TECHNICAL BULLETIN  
**Bell Helicopter**  
A Textron Company

No. 212-08-207

**SUBJECT:** UPPER CREW DOOR HINGE STRUCTURE,  
REINFORCEMENT OF.

**HELICOPTERS AFFECTED:** Model 212 helicopters serial number 30502 through 31311, 32101 through 32142 and 35001 through 35103.

Figure 1 (Sheet 1 of 4)

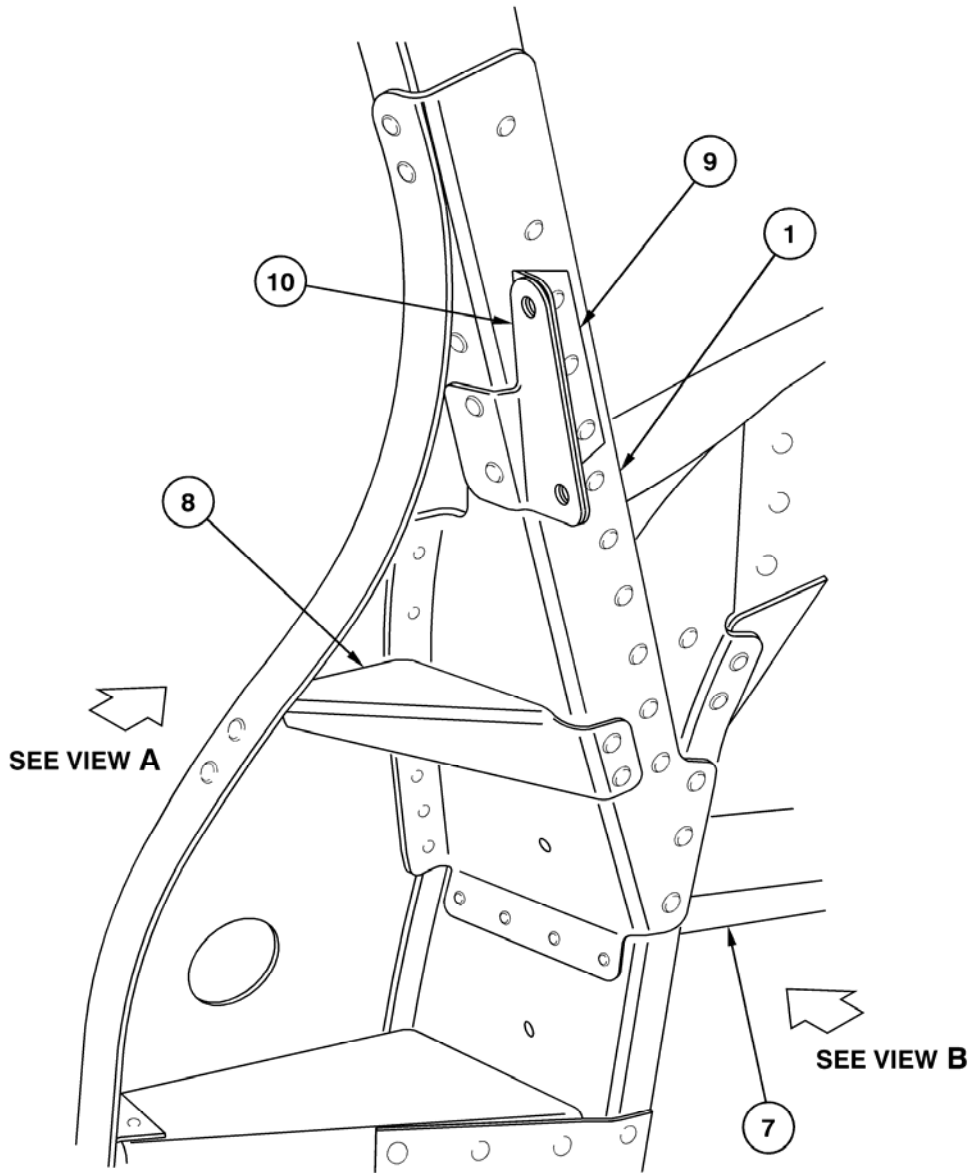
Bell Helicopter has received some reports of cracking occurring at supports P/N 204-030-662-037 & -038 (or the earlier -025 & -026) caused by the crew doors repeatedly hitting their open stop, especially under windy conditions. This bulletin provides the instructions for a simple reinforcement to the surrounding area.

5. On left side, remove instrument panel support fitting (9).
6. Remove strap (10).
7. Remove support (1) and support (8) as a unit. Remove support (8) from support (1).
8. Fit new support (1). See note 1 in Figure 1. Measure gap between forward leg of support (1) and frame (7), View B and Section C-C. If gap is less than 0.063 inch, peel or grind shim (2), taper or straight, as required to fill gap without stress on support (1) and discard shim (3). If gap is 0.063 inch or more, install shim (3) in addition to shim (2), peeled or ground as required. Secure with Cleco fasteners.

9. Fit doubler (4) and radius block (5); refer to View A. See note 1 in Figure 1. Verify for possible interference with support (8) and trim doubler as required. Trim radius block to follow edge of doubler (4) and support (1). Secure with Cleco fasteners.

1. Existing support LH (204-030-662-037)  
Existing support RH (204-030-662-038)  
New support LH (204-030-662-121)  
New support RH (204-030-662-122)
  2. Shim (120-098-05D12)
  3. Shim (204-030-662-129)
  4. Doubler LH (204-030-662-119)  
Doubler RH (204-030-662-120)
  5. Radius block (20-042-8-14)
  6. Adhesive (299-947-100 Type II, CL2)
  7. Existing frame (ref.)
  8. Existing support (ref.)
  9. Existing fitting (ref.)
  10. Existing strap (ref.), if applicable
-  Existing rivet hole, countersink this hole in doubler (4), dimple in support (1)

Figure 2

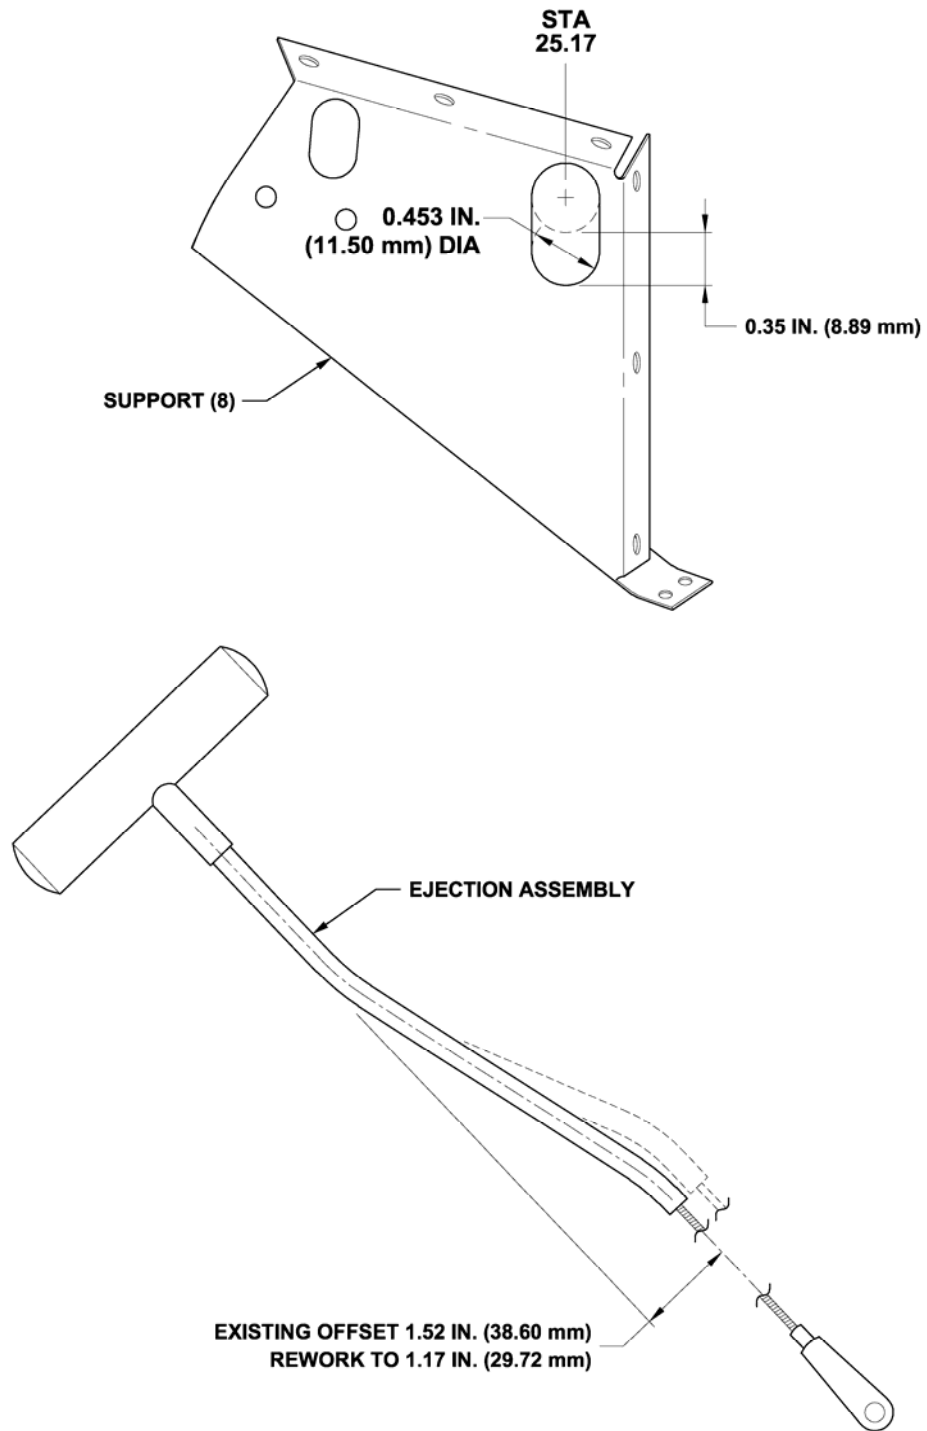
10. Rework existing support (8) or replace with new support, as per Figure 2.
11. Fit existing fitting (9) and reworked (or new) support (8). Secure with Cleco fasteners.

18. Rework existing ejection assy as per Figure 2 or replace with new ejection assy. Re-install door-jettisoning mechanism.
19. Repeat steps 5 to 18 for right side.
